IN THE DRAWINGS

REMARKS

(USSN 10/037,325)

Fig. 7

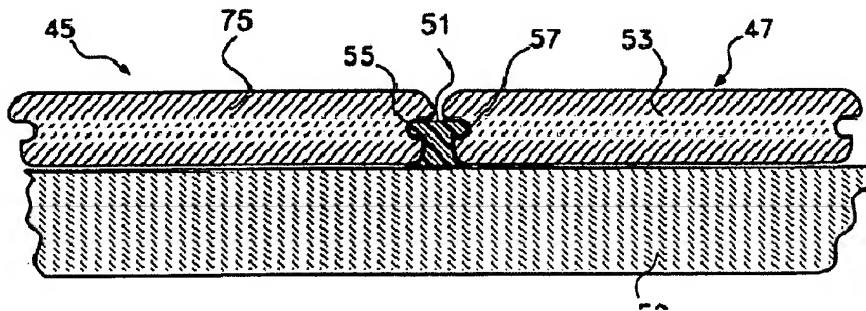
For the sake of clarity, Figure 7 is amended to delineate a portion of a decking system of the invention depicted in greater detail by newly presented Figure 9.

The Examiner has objected under 37 CFR 1.83(a) to the drawings entered on June 8, 2009, alleging that the drawings fail to show every feature of the invention specified in the claims. In particular, he maintained that the drawings fail to show the anchoring device being anchored by a metal fastener driven therethrough, as recited by claim 33 (and claims 34-38 dependent thereon).

For the sake of clarity, new FIG. 9 has been added to depict in greater detail a portion of the decking system of FIG. 7, which is exemplary of the decking system recited by claim 33. FIG. 9 depicts anchoring device 51, through which is driven a metal fastener, such as screw 52, that anchors device 51 to support board 59. The anchoring device thus joins and supports decking boards 53, 75 on the support board 59. Present FIG. 7 has been amended to indicate schematically the portion of the decking system assembly that is further depicted by FIG. 9.

In view of the amendment of FIG. 7, the addition of FIG. 9, the amendments of the specification, and the remarks set forth above, it is submitted that the objection to the drawing as failing to show every feature of the claimed invention has been mooted.

(GB 1,350,754, as annotated by the Examiner)

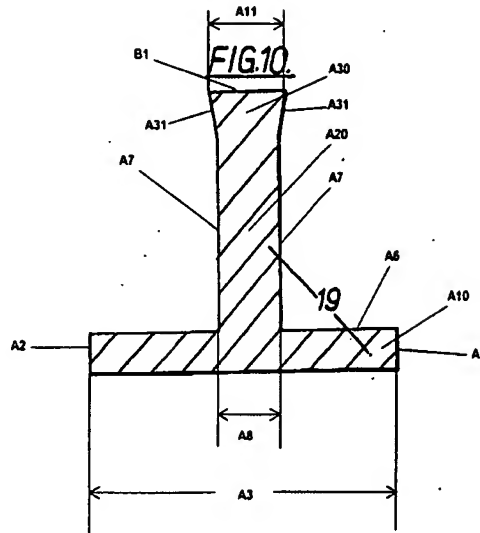
Regarding claim 29, the British patent discloses, in Figure 10, an anchoring device consisting essentially of a substantially flat horizontal top element A10, at least one substantially vertical support member A20, and a substantially flat horizontal bottom element A30. The top element A10 has a top view configuration including two sides A2 and a predetermined first width A3 as measured side to side. The first width A3 is measured at a maximum width between the sides A2. The top element A10 has an imaginary center line A4. The support member A20 is attached to an underside A6 of the top element A10 along the center line A4¹ and the support member A20 extends downwardly therefrom. The support member A20 has two sides A7 and a predetermined second width A8 as measured side to side at a maximum width. The bottom element A30 has a flat bottom view configuration, which includes sides A31 and having a generally trapezoidal shape, and a predetermined third width A11 as measured side to side at a maximum width at a trapezoidal base B1. The first width A3 is greater than the second width A8 and the third width A11. The third width A11 is greater than the second width A8. The device is made of molded plastic material (column 4, lines 72-84).

¹ *Sic* – Applicant is unable to locate any designation of A4 in the Examiner’s annotations of Fig. 10 of Child.

Applicant respectfully traverses the Examiner’s contention that Child discloses every structural feature of the anchoring device delineated by claim 29, as would be required for a proper rejection under 35 USC §102(b).

³ Applicant reiterates that what the Examiner has annotated as element A10 is never called a top element in Child, and that element A10 is depicted as the bottom portion of the strip shown in Fig. 10. The "top" nomenclature is purely a designation bestowed by the Examiner. .

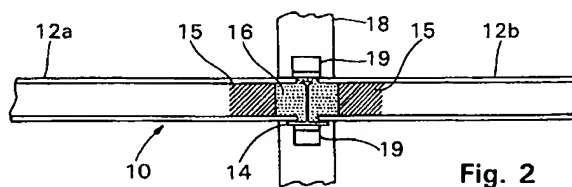
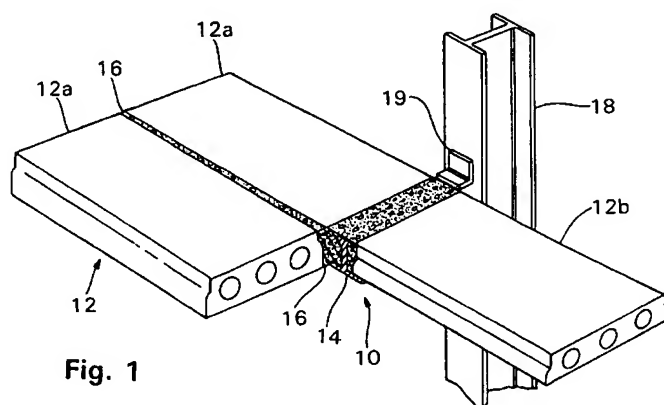
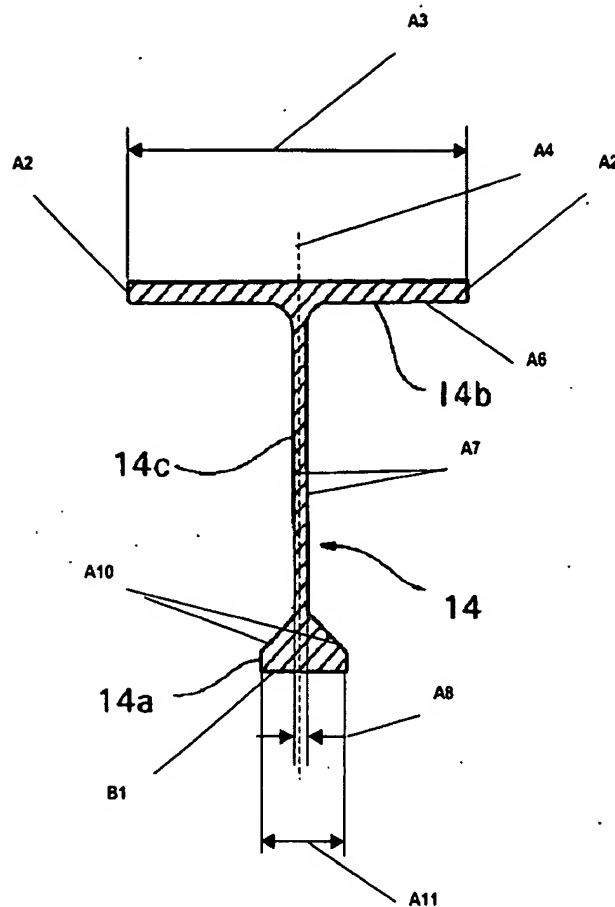
The Examiner has stated that Curtis, Jr., teaches in Figs. 2 and 4, a support column 17', 21 having recesses to allow the insertion of a fastener therethrough. He then asserts that it would have been obvious to include recesses on the vertical support member of Child to allow insertion of a fastener, thereby creating support columns between the recesses.

Applicant respectfully traverses the identification of items 17' and 21 of Curtis, Jr., as being, or even having, support columns. The Curtis specification calls items 17' and 21 a "fastening member" and a "vertical platelike body portion of a fastening member," respectively. *See* col. 2, lines 59 and 20. As seen in Fig. 3 of Curtis, there is a small hole 29 through the vertical portion of members 17 or 17'. Hole 29 is necessarily small to carry out its intended function, i.e., to permit a nail to be driven generally horizontally, through the fastener and into the adjacent decking board,

Applicant respectfully submits that a person having ordinary skill in the art would in no way regard a small hole, such as hole 29, as creating a columnar

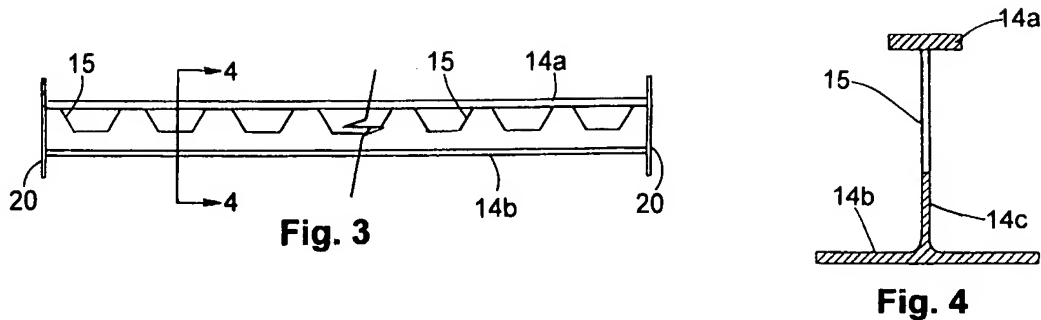
Regarding claim 29, Fisher et al. disclose, in Figure 3, an anchoring device comprising a substantially flat horizontal top element 14b, at least one substantially vertical support member 14c, and a substantially flat horizontal bottom element 14a. The top element 14b has a top view configuration including two sides A2 and a predetermined first width A3 as measured side to side. The

The present Office Action refers to the marked-up version of Fig. 3 of Fisher et al. included in a previous Office Action. Significantly, that version of Fig. 3 is depicted in an orientation that has been inverted with respect to Fig. 3 as it was originally presented in Fisher et al. The original orientation of Fig. 3 places the largest width of beam 14 (denoted as A3 by the Examiner) on the bottom, corresponding to its disposition in the finished construction shown in Figs. 1 and 2. By way of contrast, and without notice, the Examiner has placed the largest width (i.e. the width of flange 14b) on the top of the altered drawing. Applicant maintains that "top" and "bottom" as used in both Fisher et al. and the instant specification are terms of ordinary language. They

It is further clear that the inversion of beam 14 in an actual building structure employing the construction depicted by Figs. 1 and 2 of Fisher et al. would have disastrous consequences. Were the Fisher et al. beam installed in the inverted position, it inherently could not support the concrete planks, which would have to rest on an angled surface of the trapezoidal “bottom,” not on a flat surface. Clearly, no skilled artisan would contemplate such a configuration. The Fisher et al. reference does not disclose or suggest any function for dissymmetric structural steel beam 14 used in the inverted position implied by the Examiner’s recasting of Fig. 3.
